MEMORANDUM

To: Zoning Board
From: Lauren A. Wasilauski, Open Space & Stewardship Director
Date: January 17, 2024
Re: BA-04-23 Renard Management, LLC
Block 29002 Lots 49 & 50 (1026 County Route 518)
Preliminary and Final Major Site Plan with Use and Bulk Variances

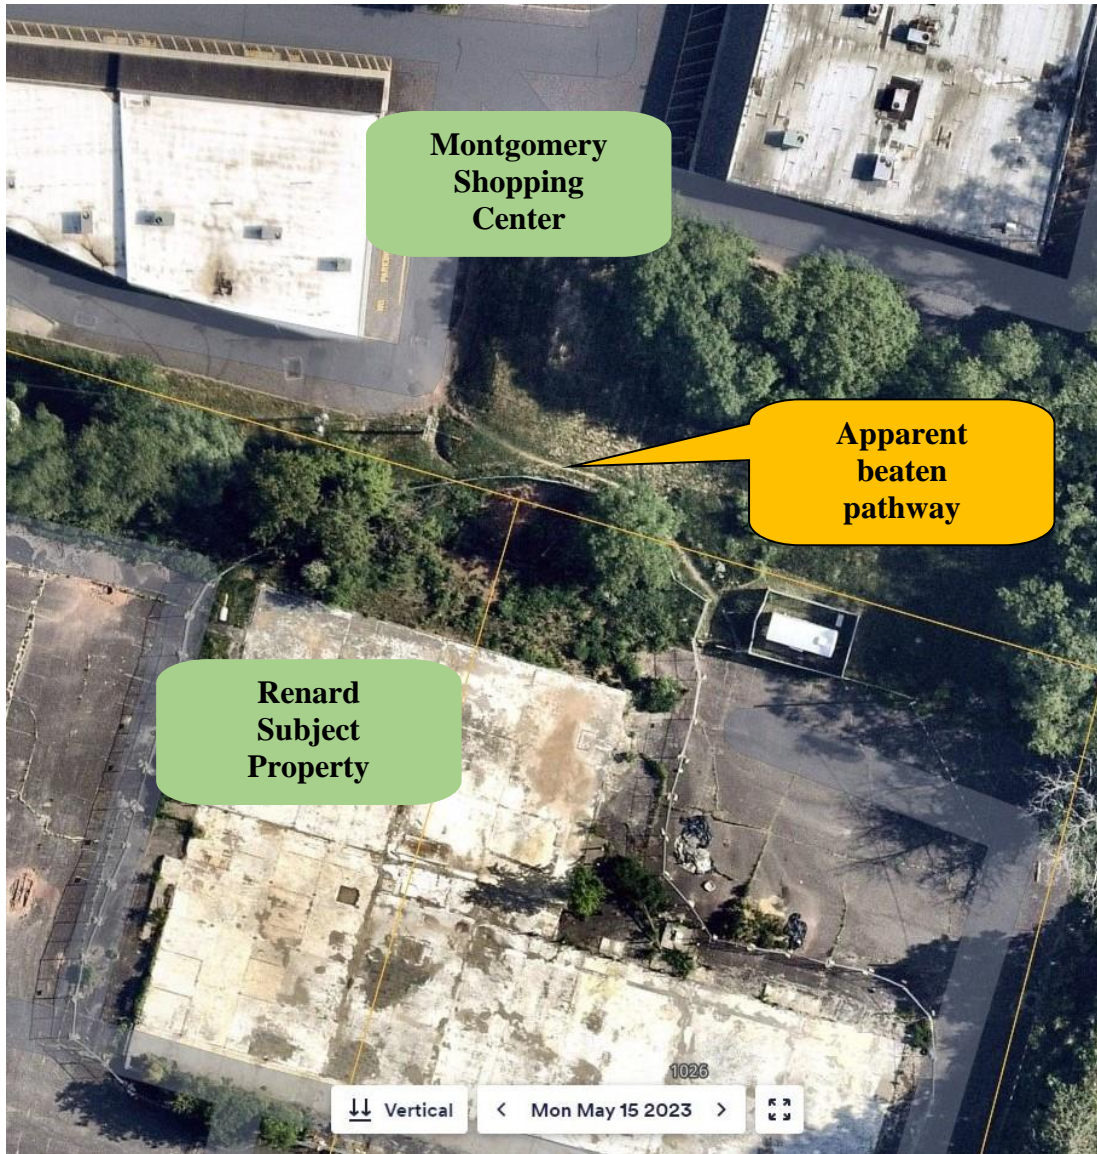
3. In looking at recent NearMap imagery, it appears that pedestrians (and possibly cyclists) are cutting through the subject property to access the Montgomery Shopping Center (see screen grab from May 15, 2023 on the following page).

- a. This office suggests the Applicant explore adding pedestrian accommodations through their property, and working with Hilton Realty of Montgomery Shopping Center to formalize this pedestrian access.

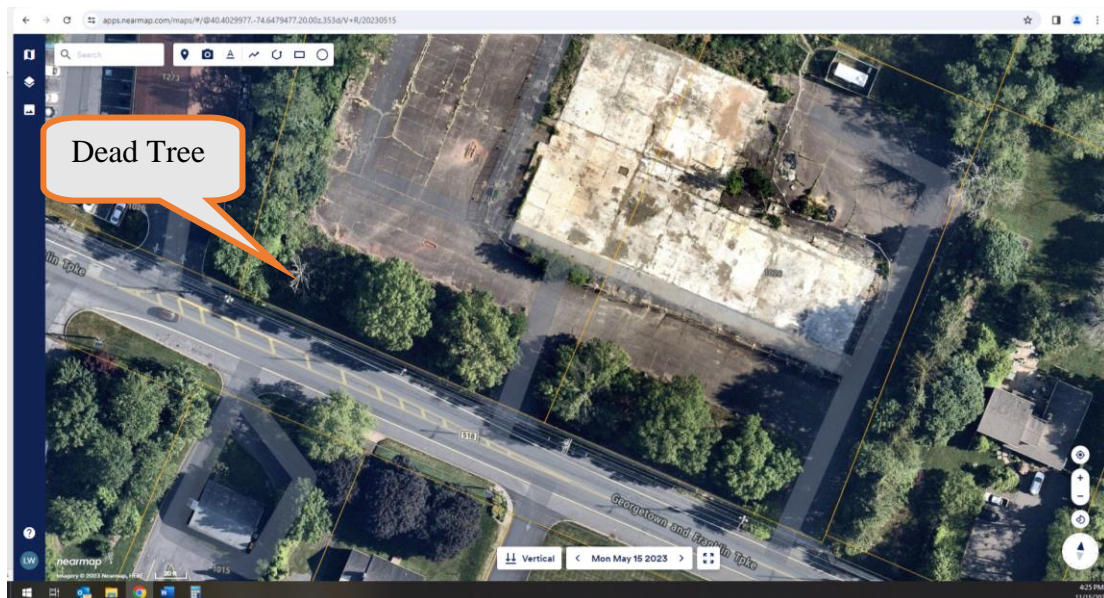
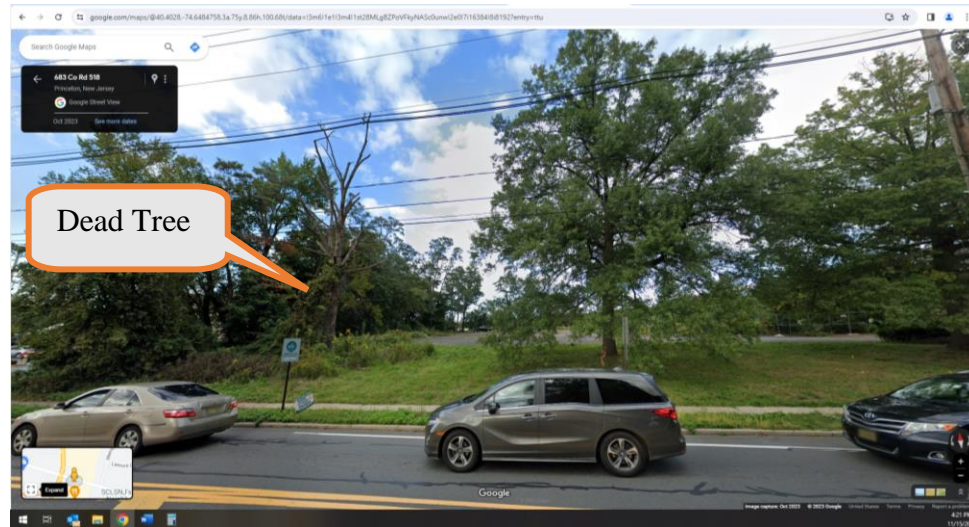
1. **Tree Removal:** Based upon the plans, 6 street trees are existing, although one at the northwest corner of the property appears to be dead based upon the Google street view (capture date October 2023) and NearMap images (capture date 5/15/2023).

- a. Three of these very large trees (30-36" DBH) are proposed for removal per sheet 3.
 - i. **This office strongly suggests that every effort should be made to preserve the live trees.** They are located within the front yard setback and don't interfere with any proposed improvements, with the possible exception of the proposed driveways, which could be reconfigured.
 - ii. These mature trees are very effective at storing stormwater, with estimates ranging from 4,000 gallons¹ to 10,000 gallons+ per tree per year². This is
